DELEGATED APPLICATION REPORT

App Ref: PL/26/0205 Householder planning permission

Address: 35 MALVERN COURT, READING, RG1 5PL

Proposal: Proposed single storey front porch extension and part conversion of existing garage to habitable space. Proposed single storey rear extension. Changes to external fenestration.

Proposed Parking Layout Plan.

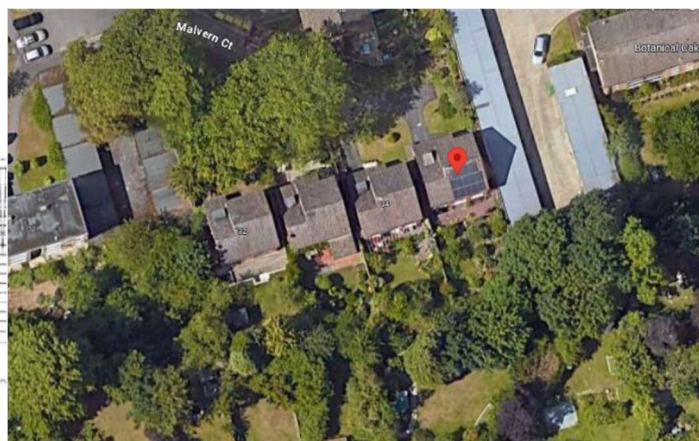
With reference to the Parking Plan, 19th February 2026, Drawing No. 097, I note that the driveway extension will remove an area of soft landscaping on the frontage. However, I note it proposes to retain the remaining existing soft landscaping, but the vegetation hasn't been plotted and has been generalised to a green area. It is clear from your site visit photographs that there is a variety of vegetation, that of which is to be removed is not clear. With any development, it is expected that any loss of soft landscaping is mitigated through efforts such as tree planting. I don't currently note any mitigation planting, hence this needs to be considered and demonstrated.

The agent confirms the driveway works will be finished in permeable tarmac.
